**Technical Service  
BULLETIN**

**WIND NOISE FROM DOOR  
GLASS WINDOW RUN**

'03 – '05 Matrix

REVISED  
NV005-05  
NVH

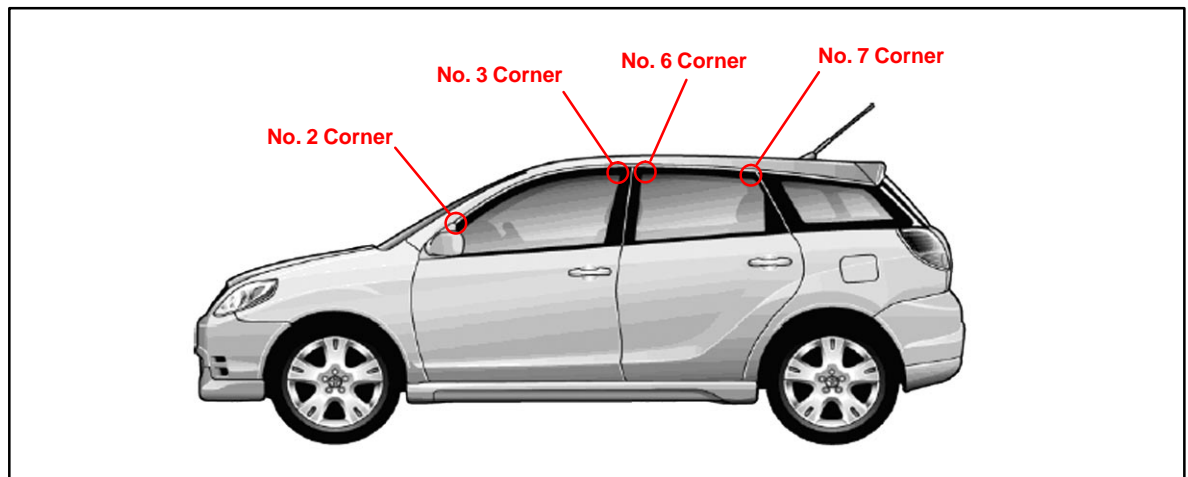
1. Place the window in the down position.
2. Remove the window run.  
Completely remove the double-sided tape remaining on the frame.
3. Thoroughly clean the door frame using a white body shop towel and Kent™ Acrysol.

4. Install the door glass window run.
  - A. Position the glass run at the No. 2 and No. 3 corners of the door frame and then attach the middle part of the run.
  - B. Insert the glass run into the window run channels.

- Do NOT apply water or lubricant to the glass run when inserting it into the door.
- Make sure the glass run fits securely into the holes of the door frame.

5. Using a plastic pry tool, press the glass run into the upper portion of the door frame to securely adhere the double-sided tape.
6. Fully close the window.
